MacDonald Park Improvements

Public Comments

Comments on Proposed Park improvements for Macdonald Park

RE: Comments on DCR's Concept Designs for Potential Improvements to
Torbert Macdonald State Park in Medford

Macdonald Park - alternative ideas for activating the park

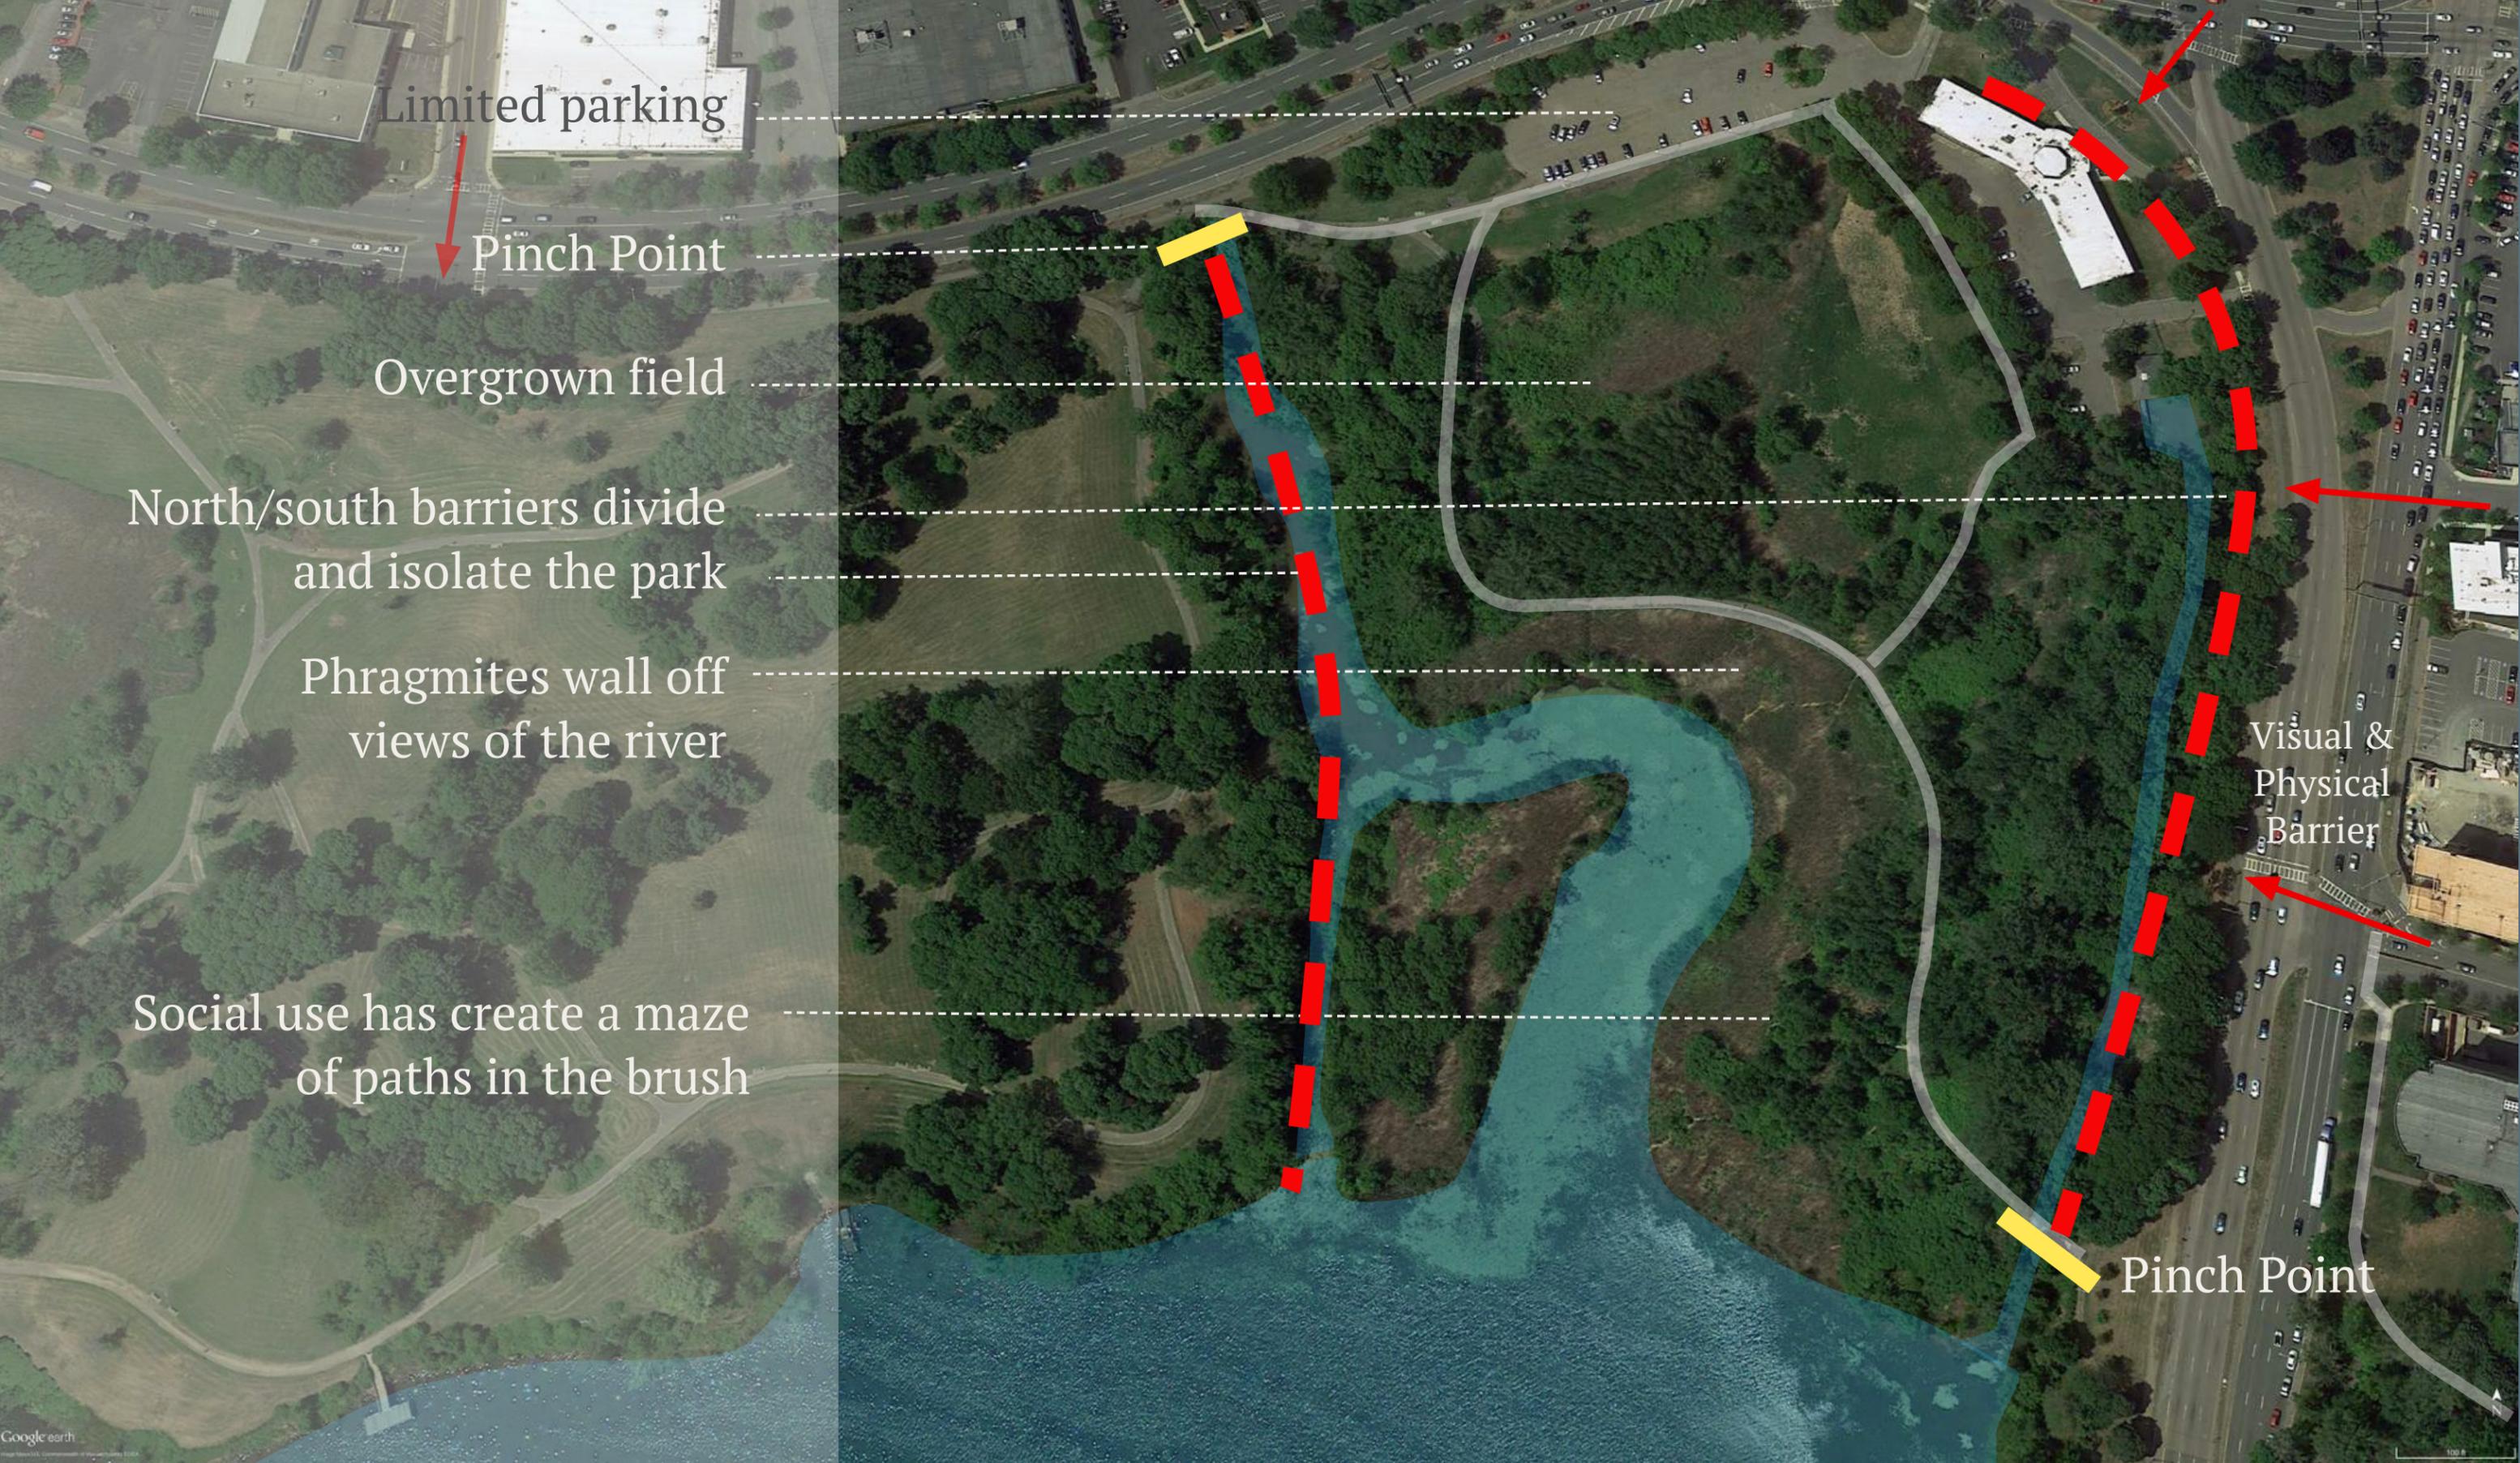
- A direct link from Station Landing and the Wellington Train Station to the park would dramatically enhance access. If the existing pedestrian bridge has to be replaced anyway at some point, why not build a modern bridge where it does its job best - directly inline with the crosswalk. It's a narrow leap across the canal and the bridge would be relatively inexpensive.

- Macdonald Park is divided almost entirely in half by a brook that emanates from an outfall at the Mystic River Parkway. As a result visitors are forced out to the edge of the parkway to get around the barrier. Providing a pedestrian bridge across the stream would overcome this barrier, offer views of the river, and help knit together the park. That in turn would help activate the park and make it safer. This is one of many alternatives that ought to be tested in a master planning process. (see attached diagrams)
